PLANNING APPLICATION NUMBER:P13/0327

Type of approval sought	Full Planning Permission
Ward	Sedgley
Applicant	Mr S. Cove
Location:	248, NORTHWAY, SEDGLEY, DUDLEY, DY3 3RL
Proposal	PART A FIRST FLOOR SIDE EXTENSION (RESUBMISSION OF WITHDRAWN APPLICATION P12/1262) PART B SINGLE STOREY REAR EXTENSION.
Recommendation Summary:	PART APPROVE & PART REFUSE (SPLIT DEC'N)

PROPOSED FRONT ELEVATION
@ 1 : 100

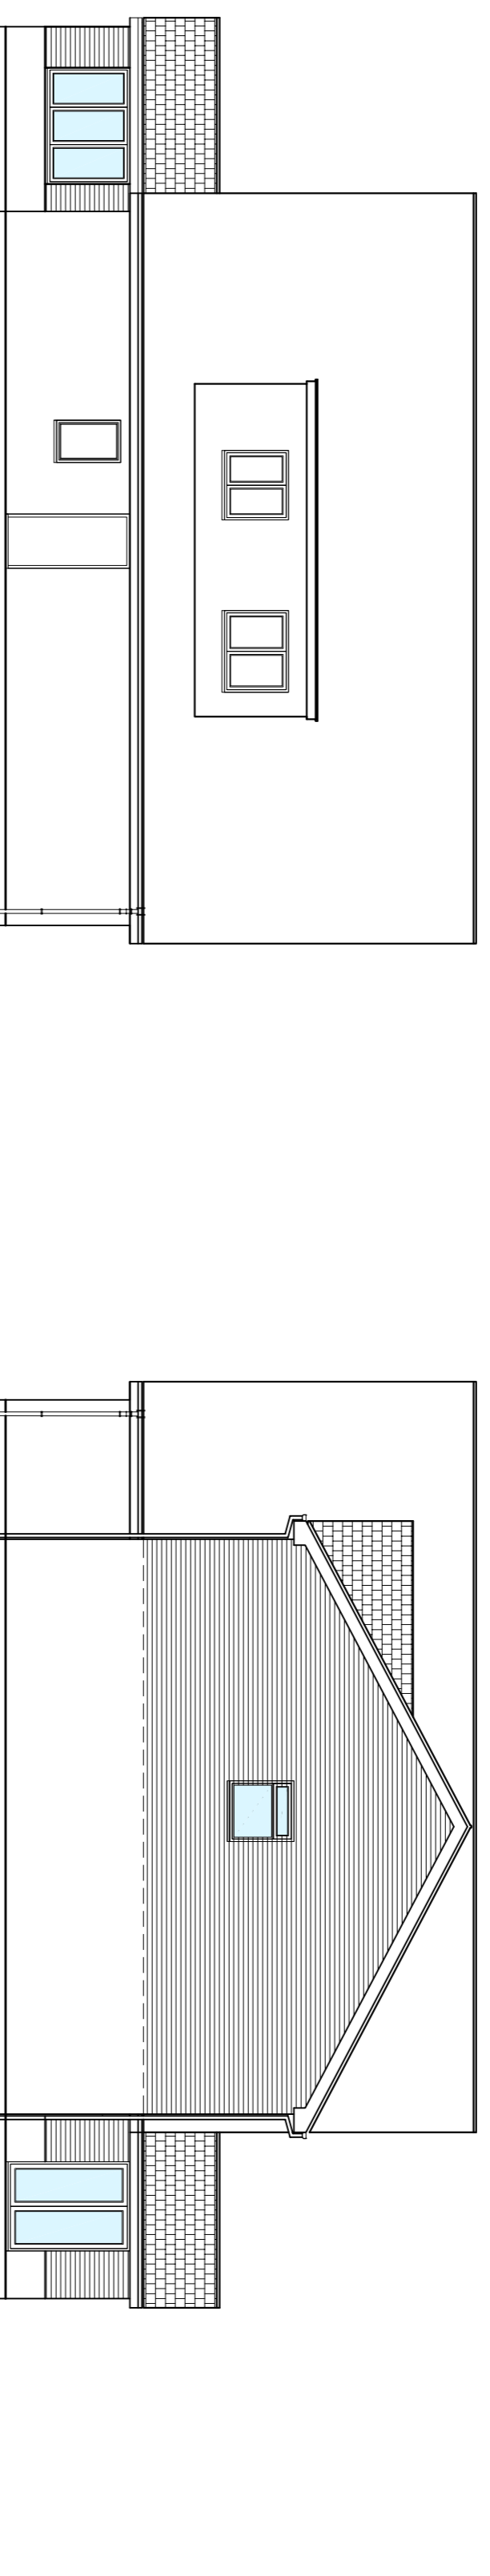
34. The proposed first floor side extension is considered to constitute poor design due to its inappropriate roof design that would form an incongruous addition when set against the unique style and appearance of the existing roof and dwelling, thereby failing to respond to the local character of the area and being detrimental to the visual appearance of the street scene.

41. The proposed first floor side extension would constitute poor design due to its inappropriate roof design that would form an incongruous addition when set against the unique style and appearance of the existing roof and dwelling thereby failing to respond to the local character of the area and being detrimental to the visual appearance of the street scene.

44. It is recommended that the first floor side extension Part A be REFUSED for the following reason(s):
 1. This particular part of the street scene of the Northway is distinctive due to the unique style and nature of the chalet style house type. The distinctiveness of the street is created by the unusual form of this house type and it is considered that the visual gap and separation that is afforded to these properties by the steep pitched roof is what defines the specific character of this part of the Northway. To allow the addition of the first floor side extension at the application site would result in the erosion of the existing pattern, rhythm, form and visual separation between the row of four identical dwellings to the detriment of the local character and distinctiveness of this particular part of the Northway. For these reasons, the proposed development would be contrary to the NPPF, policies ENV2 and ENV3

2. The proposed first floor side extension would constitute poor design due to its inappropriate roof design that would form an incongruous addition when set against the unique style and appearance of the existing roof and dwelling thereby failing to respond to the local character of the area and being detrimental to the visual appearance of the street scene. For these reasons, the proposed development would be contrary to the NPPF, policies ENV2 and ENV3 of the BCCS, saved Policy DD4 of the Dudley Unitary Development Plan and PGN17.

PROPOSED REAR ELEVATION
@ 1 : 100

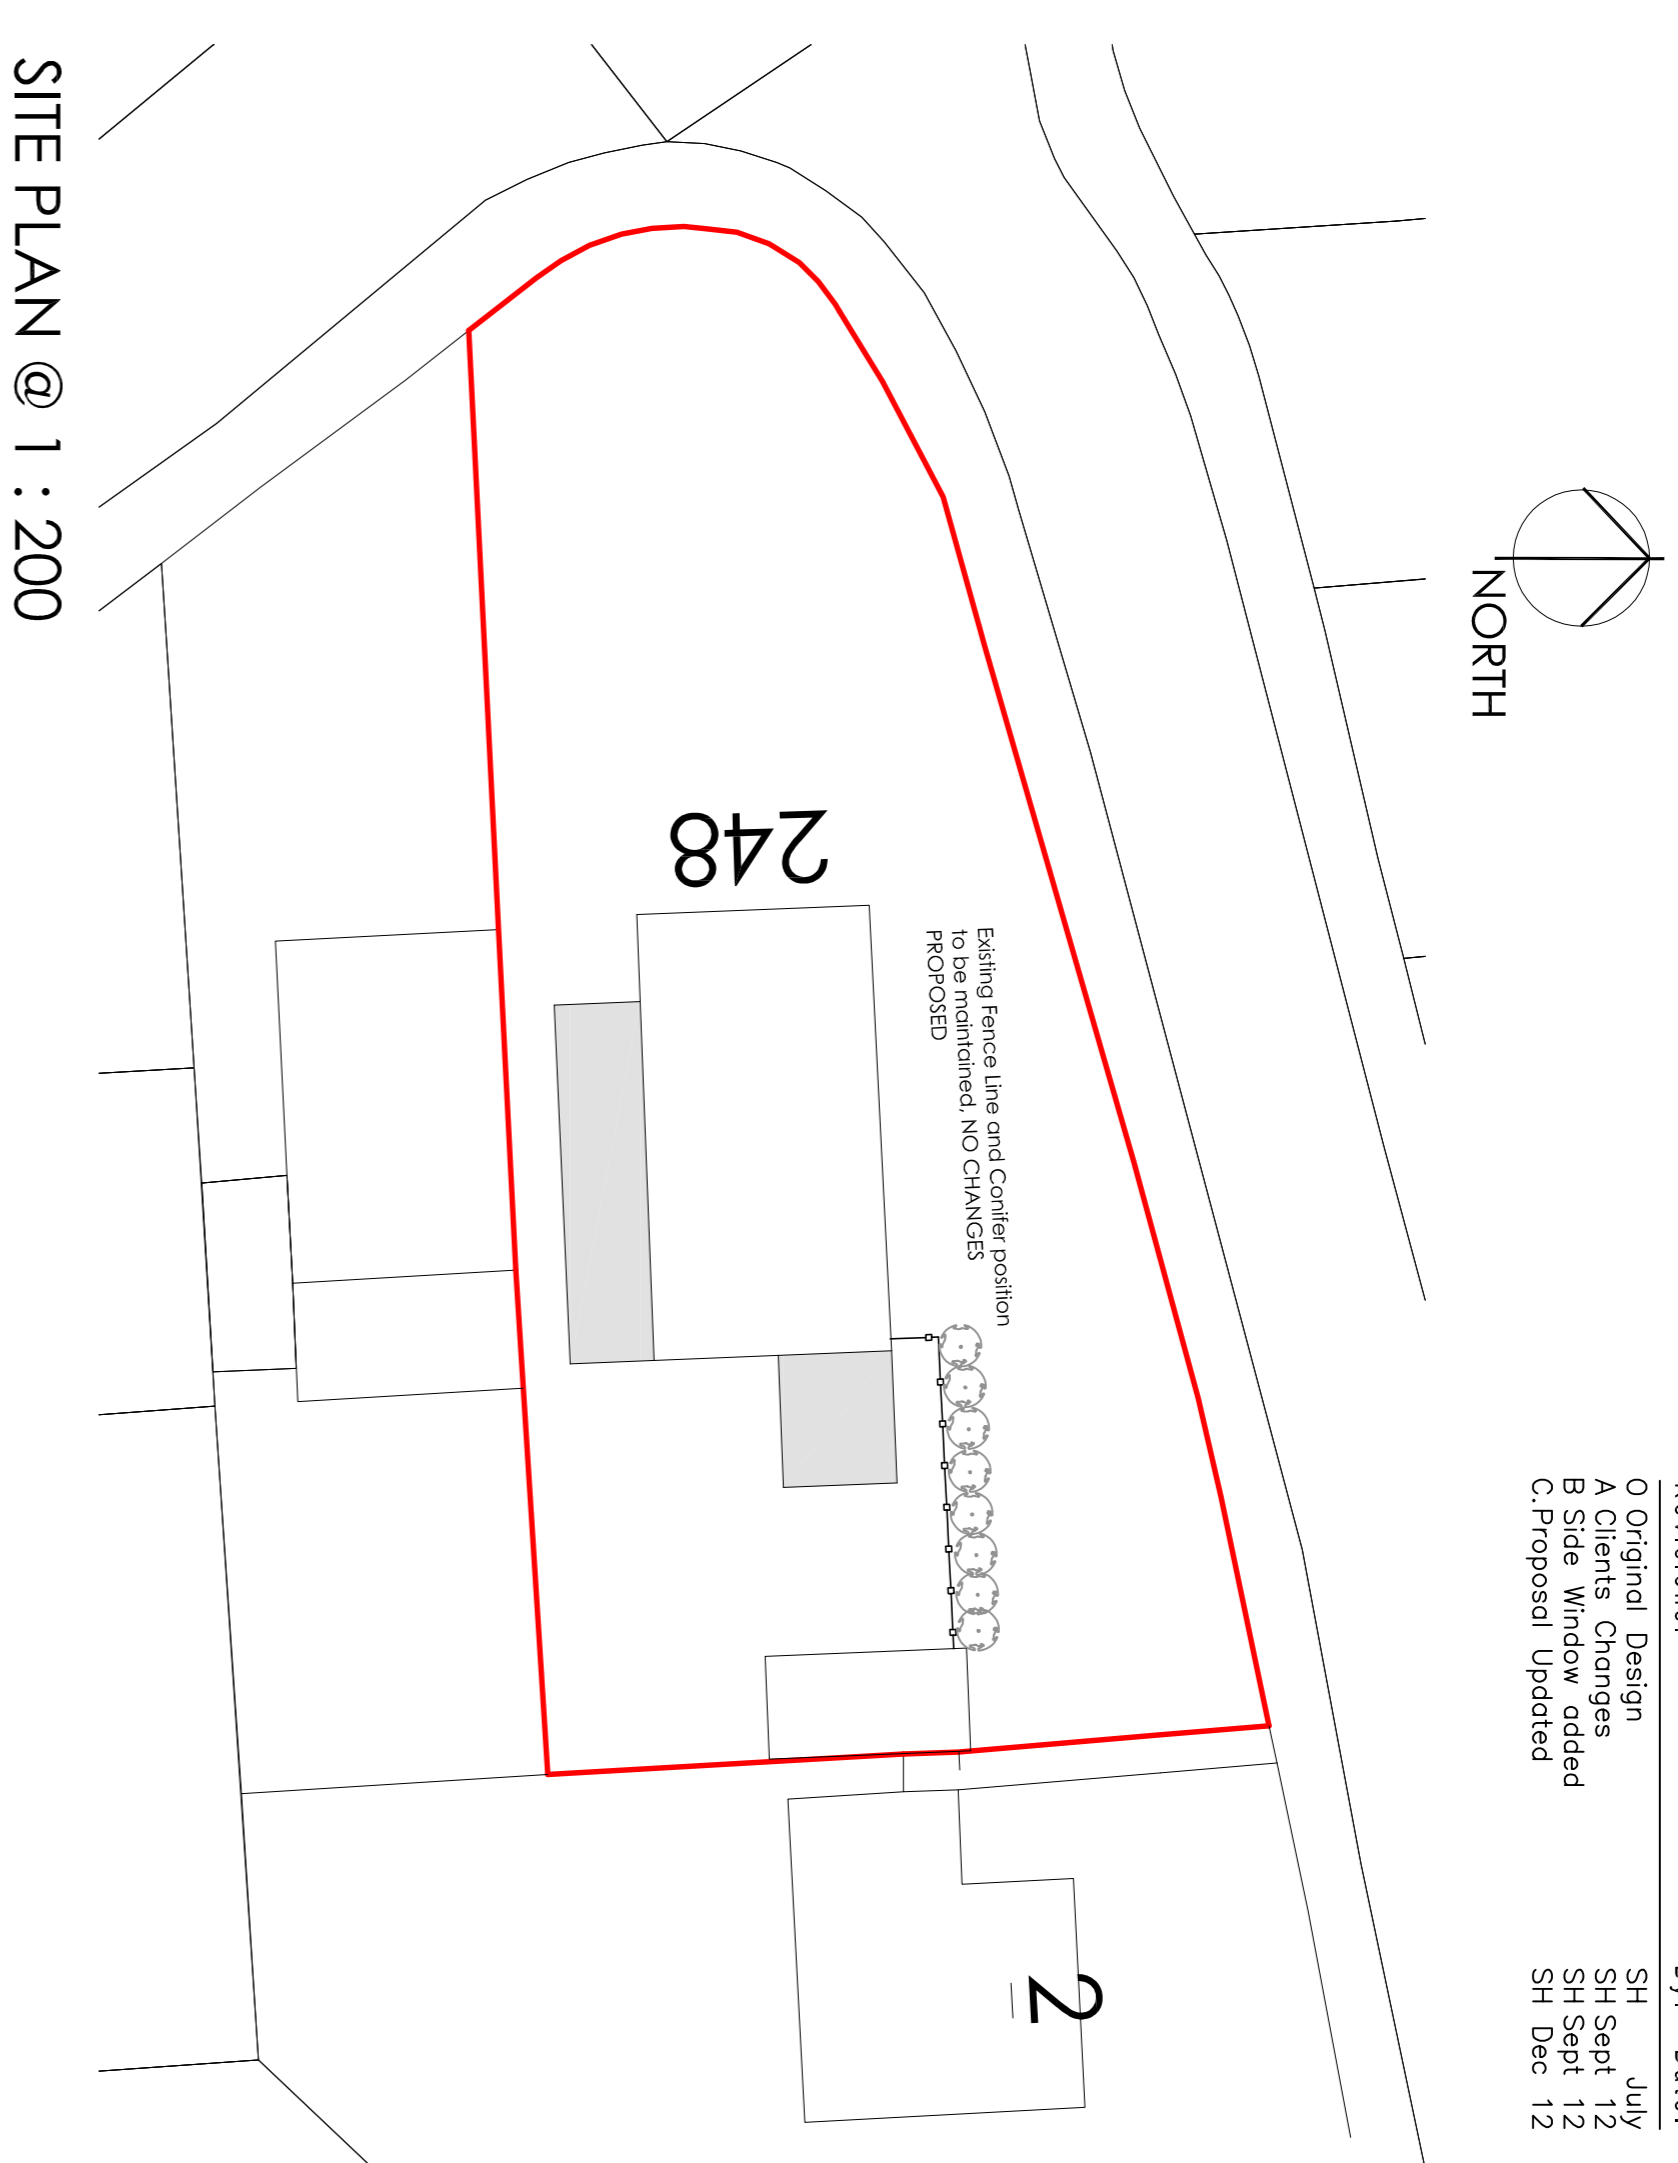
38. The first floor window in the existing rear elevation largely facing the blank side gable of no. 2 Rowena Gardens with an oblique view of the private amenity space of this neighbouring property. The proposed first floor rear window would directly face and look into the rear garden space associated with no. 2 Rowena gardens and would only be sited 11m away from the side boundary of this property. The reduced separation caused by the already extended property from the original separation distance of 14m from no. 2 Rowena Gardens and the fact that the window would directly face into the private amenity space of this property would result in an unacceptable impact in terms of overlooking and therefore a loss of privacy to the occupiers of this property thereby being contrary to saved Policy DD4 of the Adopted Dudley Unitary Development Plan and PGN17 and PGN12.

42. The proposed window on the first floor side extension would face directly into the private amenity space of no. 2 Rowena Gardens and due to the limited separated distance of only 11 metres between the rear extension and the side boundary of this neighbouring property would result in an unacceptable impact in terms of overlooking and therefore a loss of privacy to the occupiers of this property.

3. The proposed window on the first floor rear extension would face directly face into the private amenity space of no. 2 Rowena Gardens and due to the limited separated distance of only 11 metres between the rear extension and the side boundary of this neighbouring property would result in an unacceptable impact in terms of overlooking and therefore a loss of privacy to the occupiers of this property. For these reasons, the proposed development would be contrary to saved Policy DD4 of the Dudley Unitary Development Plan.
